NMA Justification Statement

This document has been prepared in support of the Non-Material Amendment application **PL/26/0044/NMA**. It provides additional technical justification and clarification for the amendments proposed, demonstrating that the revisions are necessary to address site-specific constraints while maintaining the approved design intent and ensuring compliance with relevant planning and environmental requirements.

(Extract from Drawing No 2092-ESC-00-ZZ-DR-E-2101 P2)

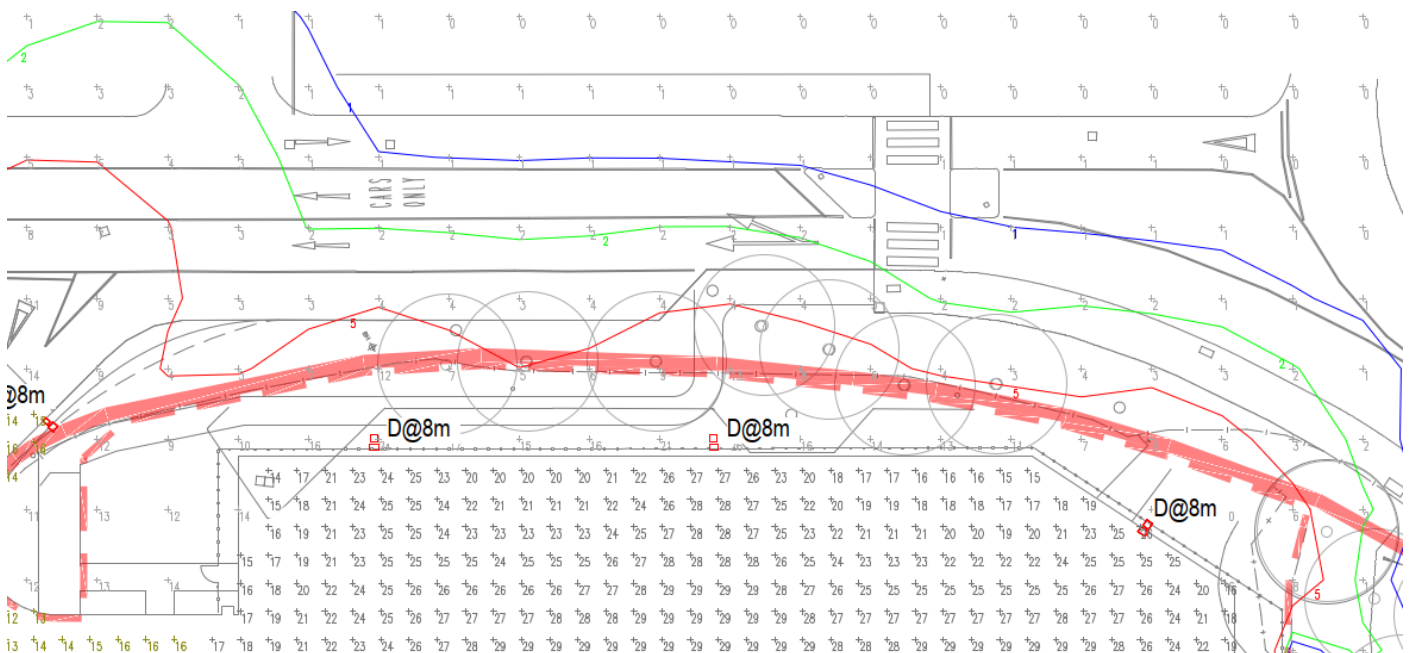
Area 1 – Boundary Adjacent Unit 2, Service Yard Boundary (Drawing No 2092-ESC-00-ZZ-DR-E-2101 P2)

- Lux level detail has been expanded to show levels at each specific spot
- Further Lux Isolines have been included to aid understanding for offsite split.
- Previously offsite split mitigation measures have already been including Column heights reduced to 8m and the installation of Backshield spill protection devices. Timeclock and photocell devices to switch off lighting out of hours.
- Use of a lower service yard lux level of 30lux to mitigate spill.
- It should also be noted that a significant lux level is already applied on the trees in this area from the main carriageway into Tesco's entrance, refer to image provided below.

(Extract from Drawing No 2092-ESC-00-ZZ-DR-E-2101 P2)

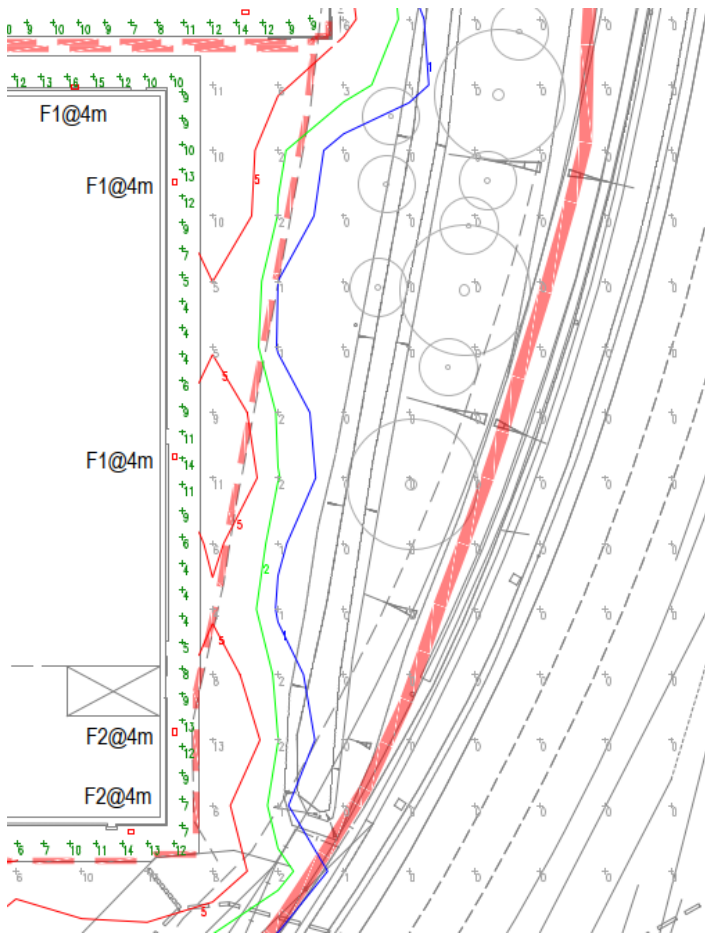
Area 2 – Boundary Adjacent Unit 2, Service Yard Boundary (Drawing No 2092-ESC-00-ZZ-DR-E-2101 P2)

- Lux level detail has been expanded to show levels at each specific spot
- Further Lux Isolines have been included to aid understanding for offsite split.
- Previously offsite split mitigation measures have already been including the use of low wattage fittings and a reduced mounting height of 4 metres. Timeclock and photocell devices to switch off lighting out of hours.
- Lux level split across this area is very low.

'It is considered that the design of the lighting strategy successfully avoids, or sufficiently limits, artificial light spill on retained vegetation of ecological interest, as well as the proposed ecological enhancement features (i.e. bat boxes). As such, it is considered that the integrity of the site for nocturnal species, and specifically foraging and commuting bats, is maintained and the development is in accordance with relevant guidance.'
